Staff Report & Recommendation

Historic Preservation Board

SUBJECT: HPB20-0380, **550 Washington Avenue.**

550 Washington Avenue, partial south elevation, Permit No. 21003

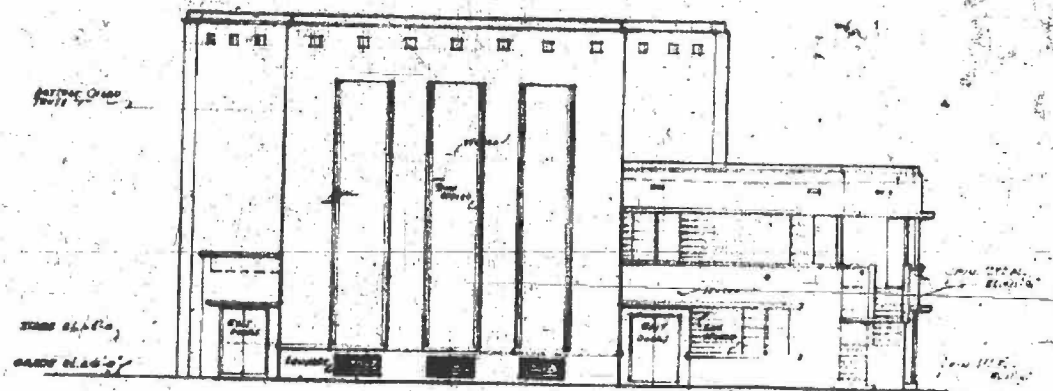
Finally, a 1-story ground level addition is proposed to be constructed on the south side of the building adjacent to the original 8-unit apartment portion of the building. The south wall at the ground level of the apartment building is proposed to be removed in order to allow for the expansion of the kitchen area into the new addition. Although the construction of this new addition will substantially obscure the ground level south façade, staff would note that the second floor exterior corridor of the south elevation, with decorative pipe columns, is proposed

to be retained. Additionally, staff is recommending that both levels at the western end of the building be restored in a manner consistent with available historic documentation, including original windows openings, muntin configurations and horizontal banding between window openings. Further, staff recommends that the proposed mechanical screening at the roof of the original apartment building be setback a minimum of 20'-0" from the Euclid Avenue property line.

- c. The westernmost portion of the original apartment building shall be restored consent with available historic documentation including original windows openings, muntin configurations and horizontal banding between window openings, in a manner to be reviewed and approved by staff consistent with the Certificate of Appropriateness Criteria and/or the directions from the Board.
- d. The proposed mechanical screening at the roof of the original apartment building shall be setback a minimum of 20'-0" from the Euclid Avenue property line, in a manner to be reviewed and approved by staff consistent with the Certificate of Appropriateness Criteria and/or the directions from the Board.
